Jefferson Proving Ground Madison, Indiana

Draft Final Phase II Remedial Investigation

Re: Draft Final Remedial Investigation
Jefferson Proving Ground,
Madison, IN

Figure 8.7-l. Ecological Study Area for Explosive Burn Area and Abandoned Landfill (Sites 3/4)

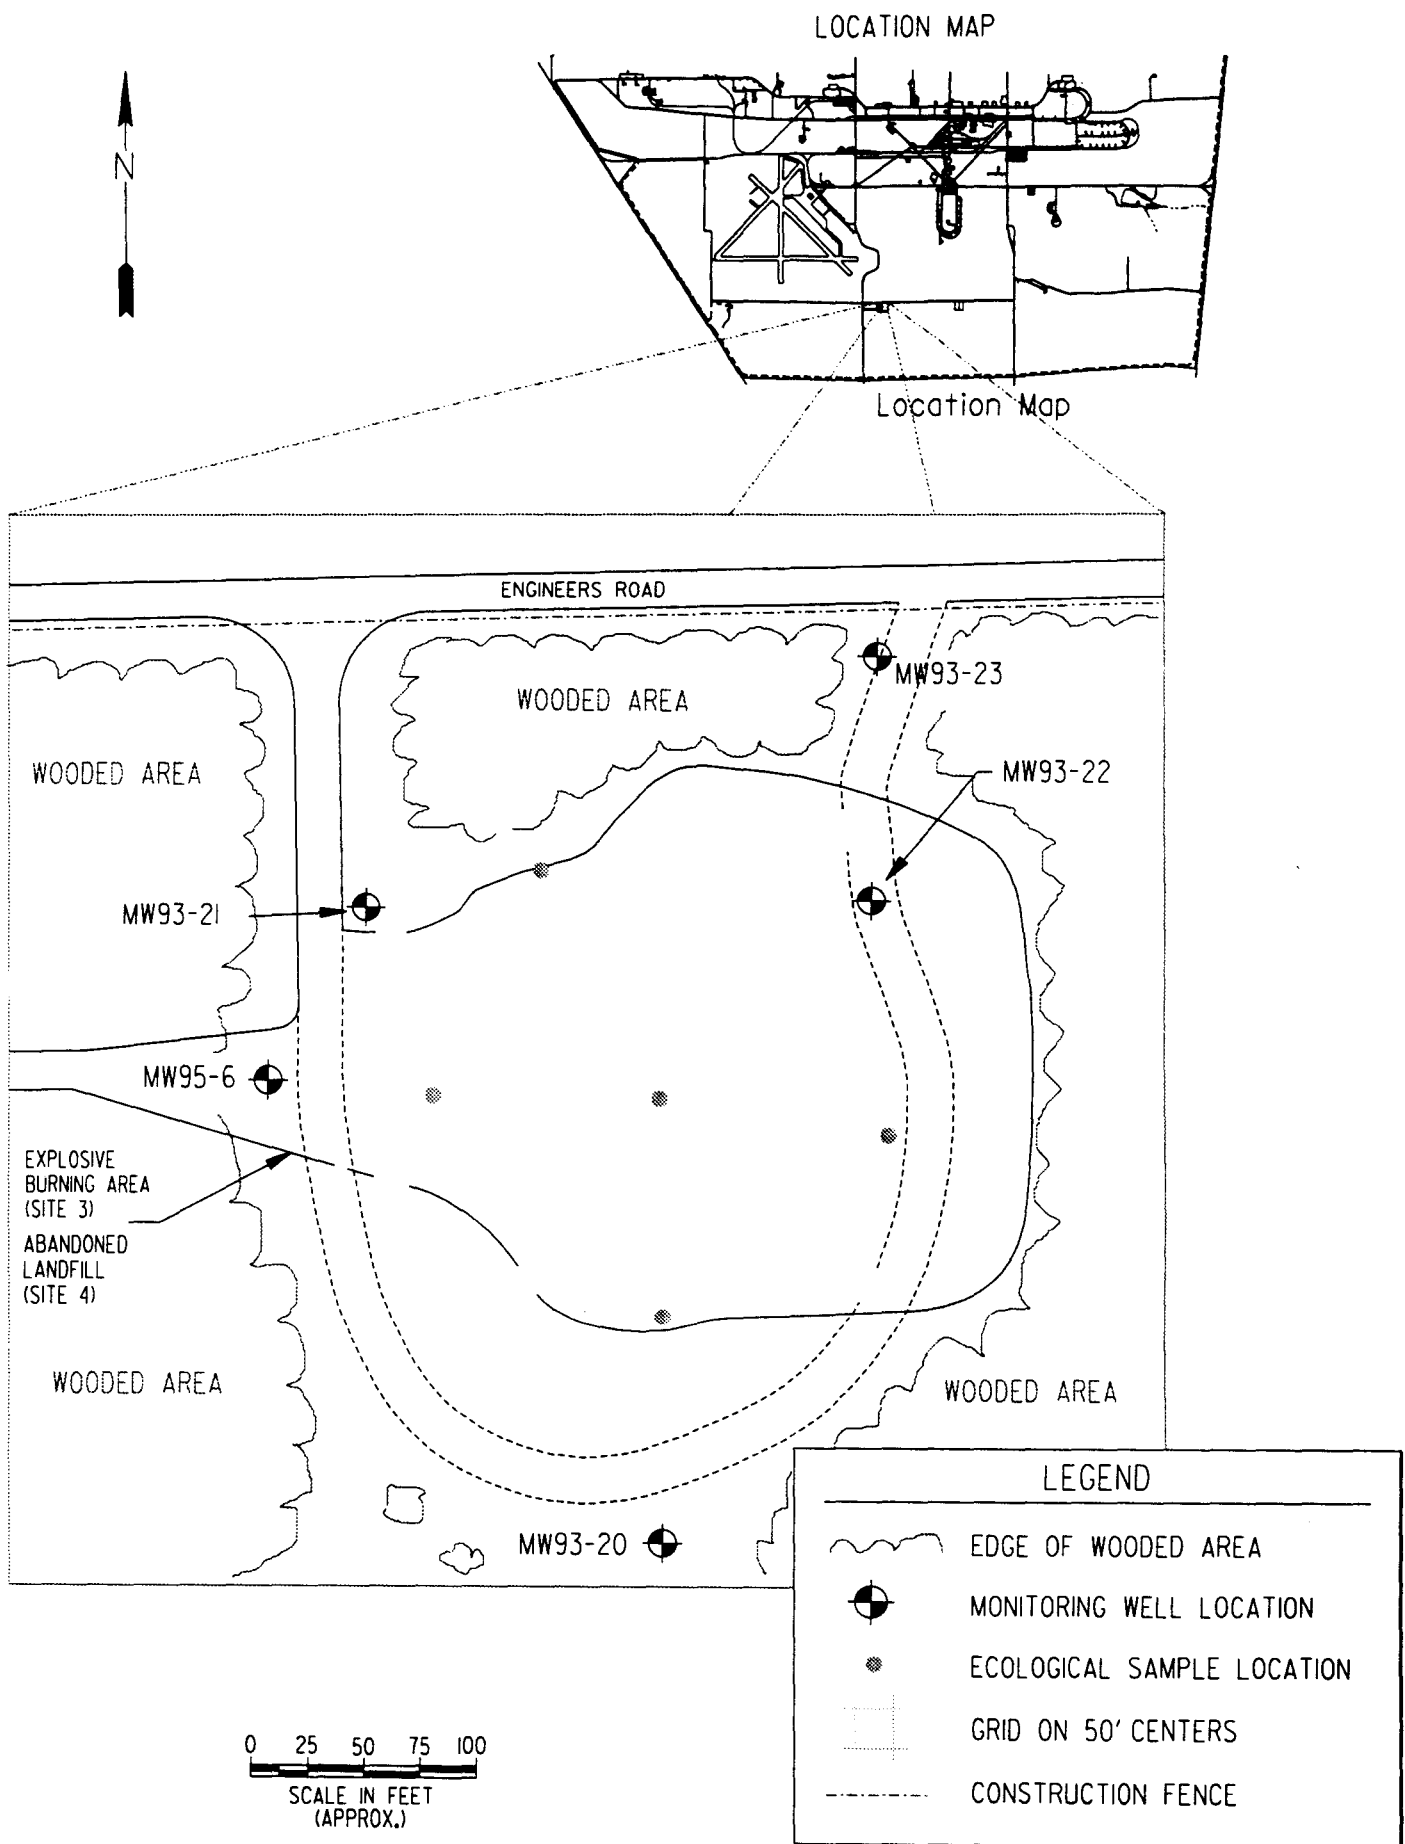
| Comment # | Section | Comment (EPA/IDEM as indicated in comment number) | Original Response to Comment (ET) | MW Revised Response (if applicable) | Agency Concur |
|-----------|------------------------|---|---|---|---------------|
| EPA201 | 08.7.1 Figure 8.7-1 | 18. Section 8.7.1, Ecological Site Description, Page 8-137: the text states that the Explosive Burn Area and Abandoned Landfill consist of infrequently maintained grassland. It should be noted that the site appears to contain grassland habitats which may be used by the federal species of concern. Please refer to Specific Comment No. 3. | From an ecological standpoint, it is unfortunate that the leaseholder may plow all or most of the remaining old-field habitats referred to in this comment. At present, the area near the abandoned landfill is fenced, and the area has been left relatively undisturbed. A statement will be added to the site description in this section that refers to the grassland as potential habitat for the Henslow's sparrow. Please also refer to response to specific comment No. 6 (EPA189). The Henslow’s sparrow is not a Federally listed T&E species, and the grassland habitat north of the Firing Line represents its preferred nesting habitat. The rapid change of habitats, as well as the future (now current) use, is the reason that habitat maps were not included in the DERA. It is also the reason that the DERA focuses mainly on receptors that can tolerate extensive human disturbance, such as mice, foxes, and rabbits. These agricultural activities are beyond the Army's control, and are what is to be expected when privatization of DOD facilities occurs. | No response needed. | |

Figure 10-5. Interim Measures Confirmation and Sampling Locations for Soils
Red Lead Disposal Area (Site 7) and the Temporary Storage Area at
Building 2II (Site 2IB)

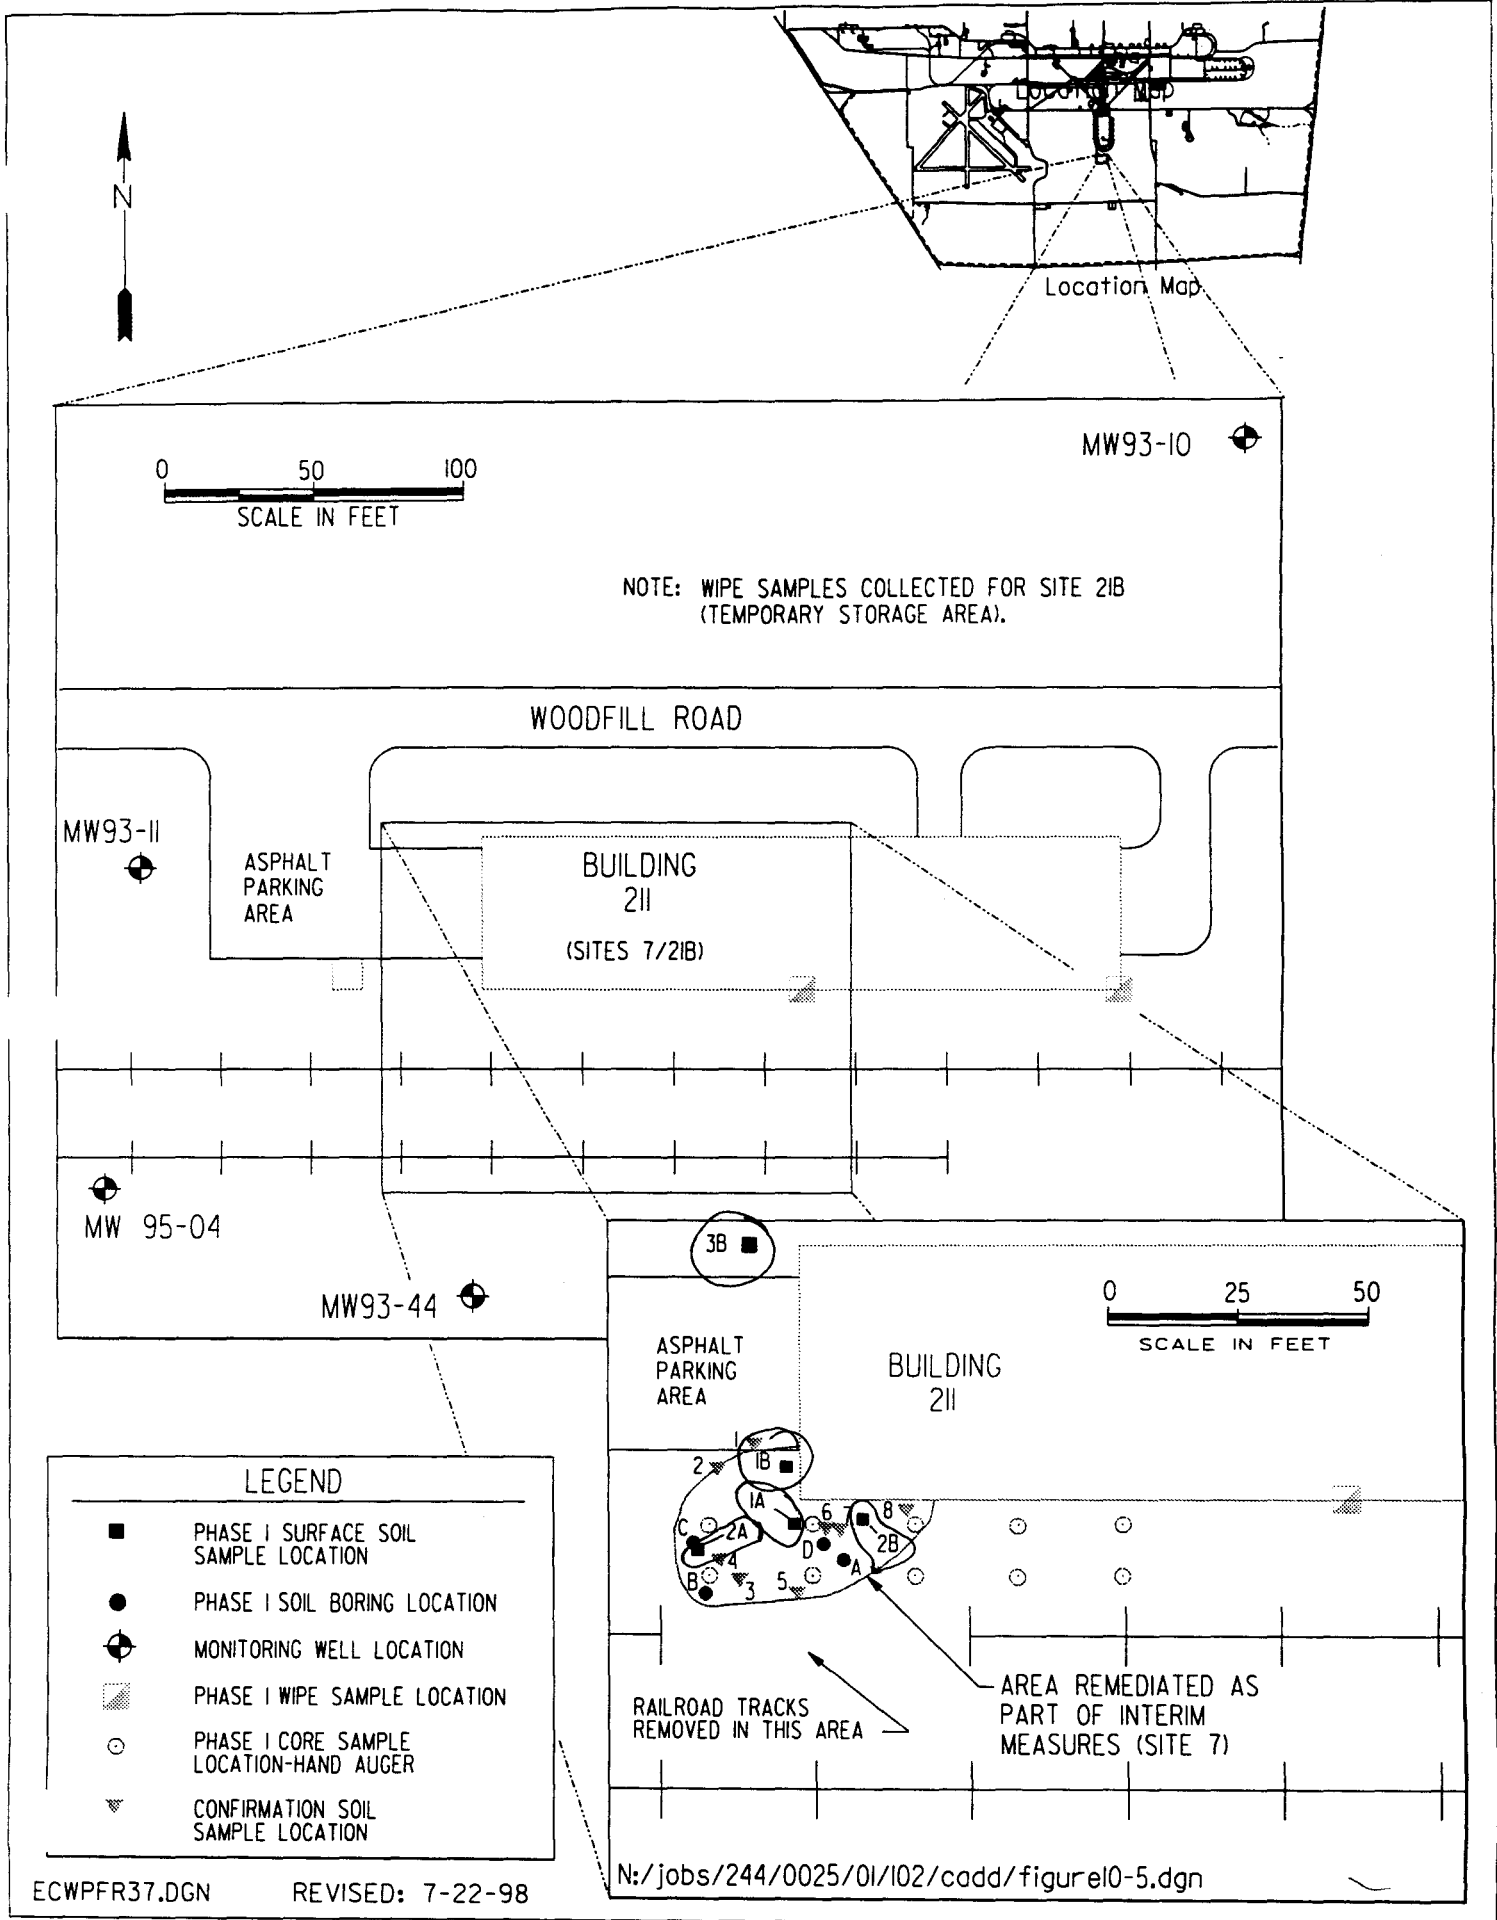
| Comment # | Section | IDEM 30 May 2002 Comment | Army Response Submitted 21 June 2002 | IDEM Evaluation of Response | Resolved (yes/no) |
|-----------|--------------------------|---|---|---|-------------------|
| IDEM 23 | Sec 10.5.2.1 | There is no reference to a map identifying sampling locations for Site 21B. Therefore, the extent of contamination could not be determined. Please provide this map. | Figure 10-5 contains the sample locations. | | Yes |

Figure II-2. Confirmation Sampling Locations at the Small Arms Firing Range (Site 8)

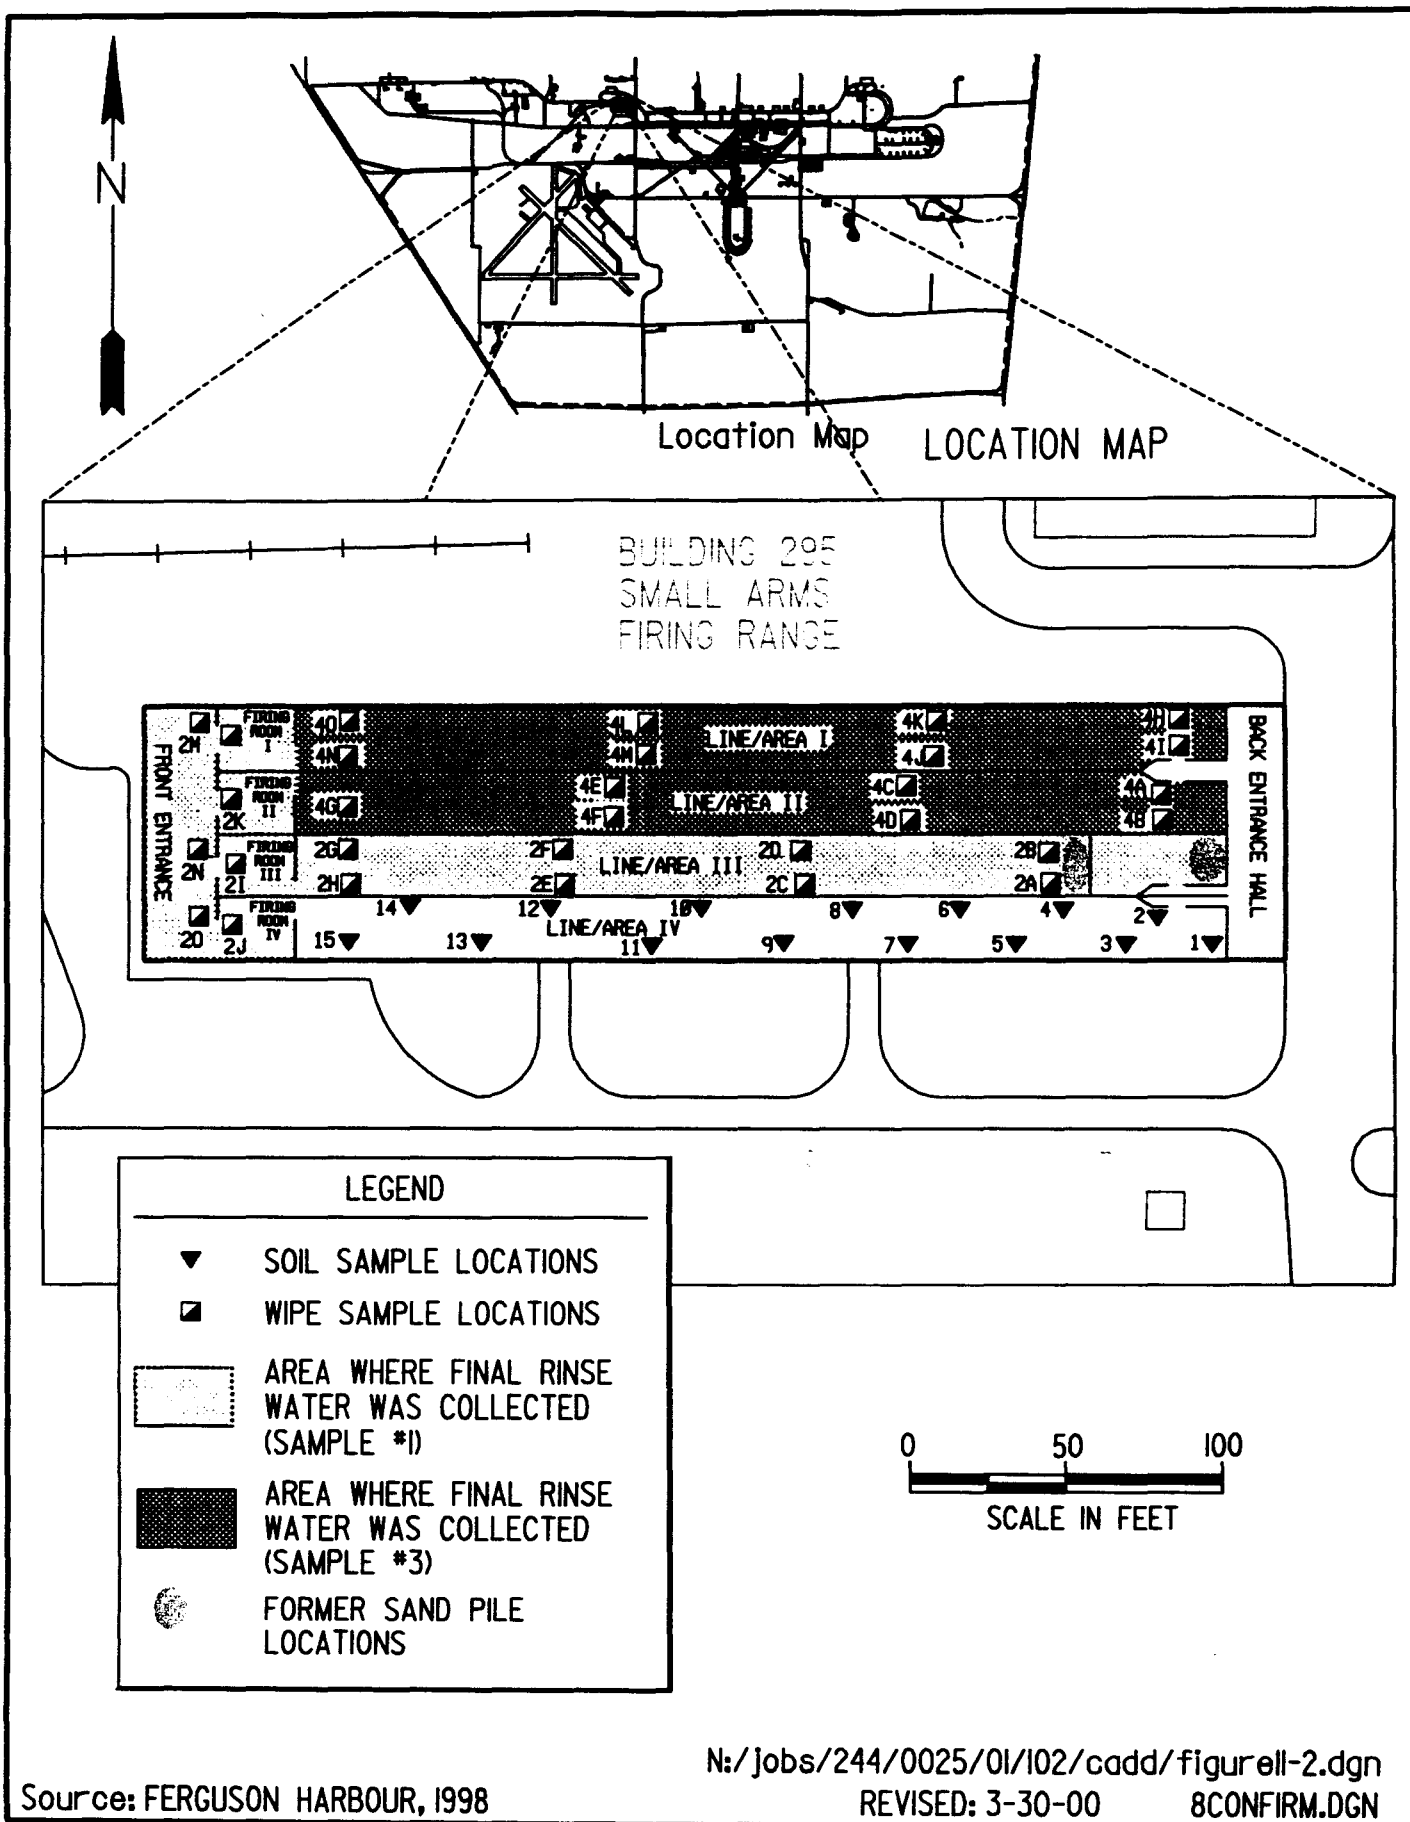
| Comment # | Section | Comment (EPA/IDEM as indicated in comment number) | Original Response to Comment (ET) | MW Revised Response (if applicable) | Agency Concur |
|-----------|--|--|---|--|---------------|
| EPA174 | 11.3.3.7, 11.4.4, 11.8, and Figure 11-2. | 50. Page 11-11, Section 11.8, Conclusions and Recommendations: Site 8 has been recommended for NFA status pending the removal of sand and soils from bullet traps inside range and cleaning of concrete and inside steel surfaces. Confirmatory post-remediation samples results were not available at the time this determination was made and are not presented within the discussion of Site 8. Any subsequent revisions of this risk assessment should include the post remediation confirmatory sampling results to defend the selection of this site for no further action. | Data were just recently made available to the authors. The confirmatory results will be added to the revised report. | Confirmation sampling results are in the April 2000 Technical Memorandum, No Further Action is Planned at Site 8. Sampling locations are added to Figure 11-2 and a discussion is included throughout the Section. | |
